STERLING RANCH SKETCH PLAN AMENDMENT & REZONES

LETTER OF INTENT

OCTOBER 2023

Approved Sterling Ranch Sketch Plan

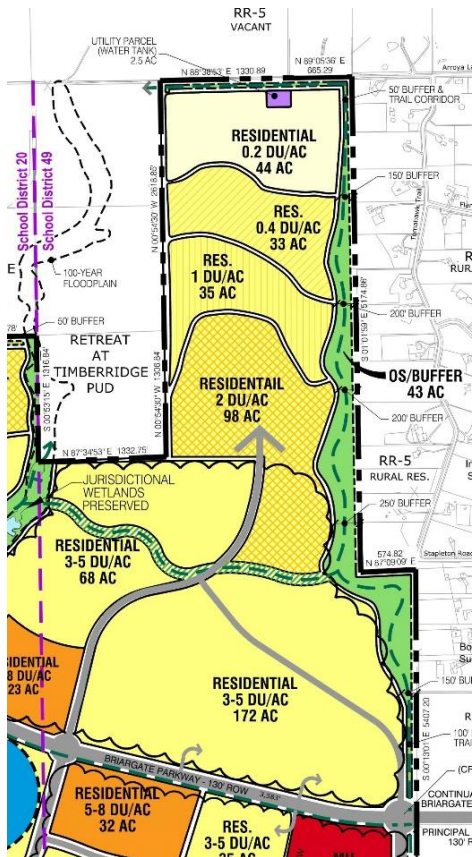
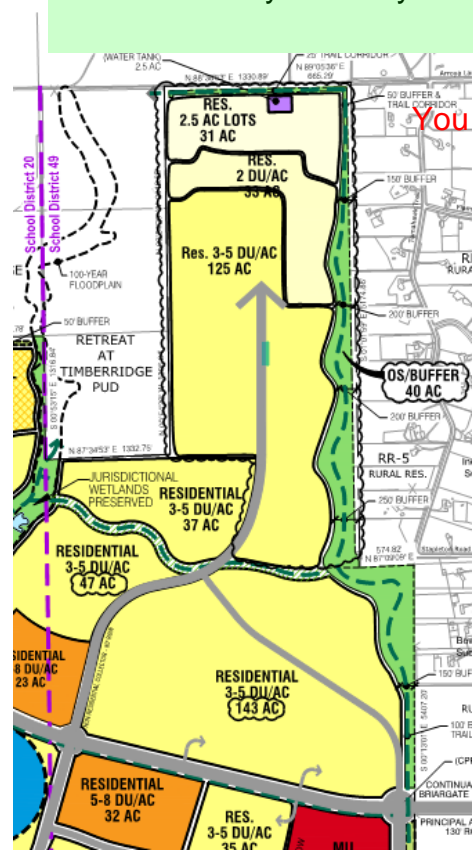
Excellent clarity - thank you

You are most welcome!

Rezones ← **Rezones (Map Amendment)** ← **Revised**

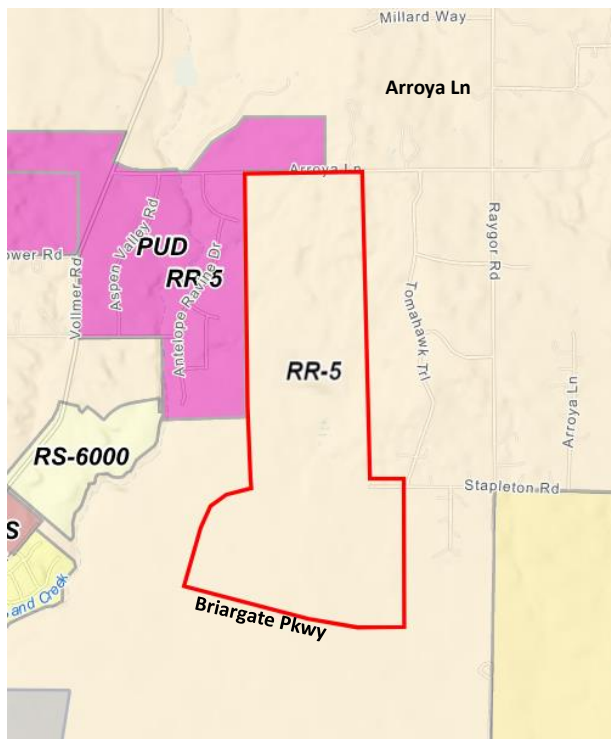
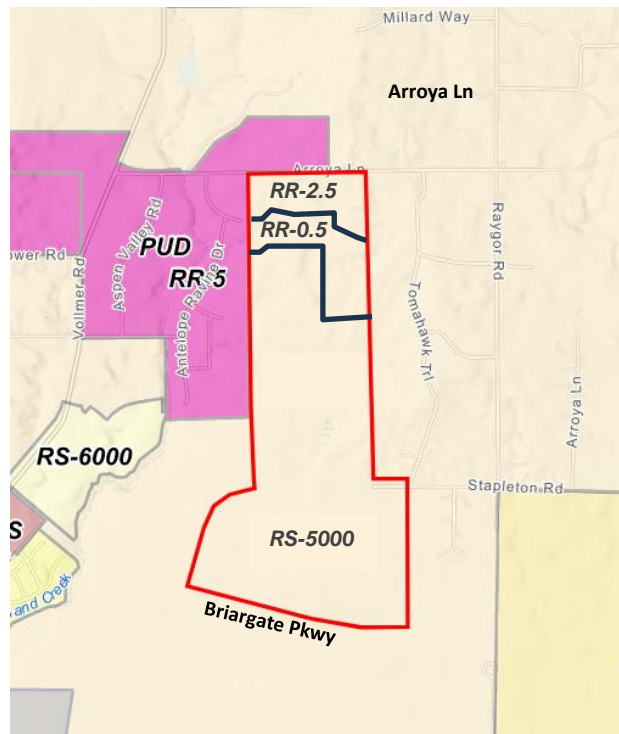
the acreage is reduced on the map
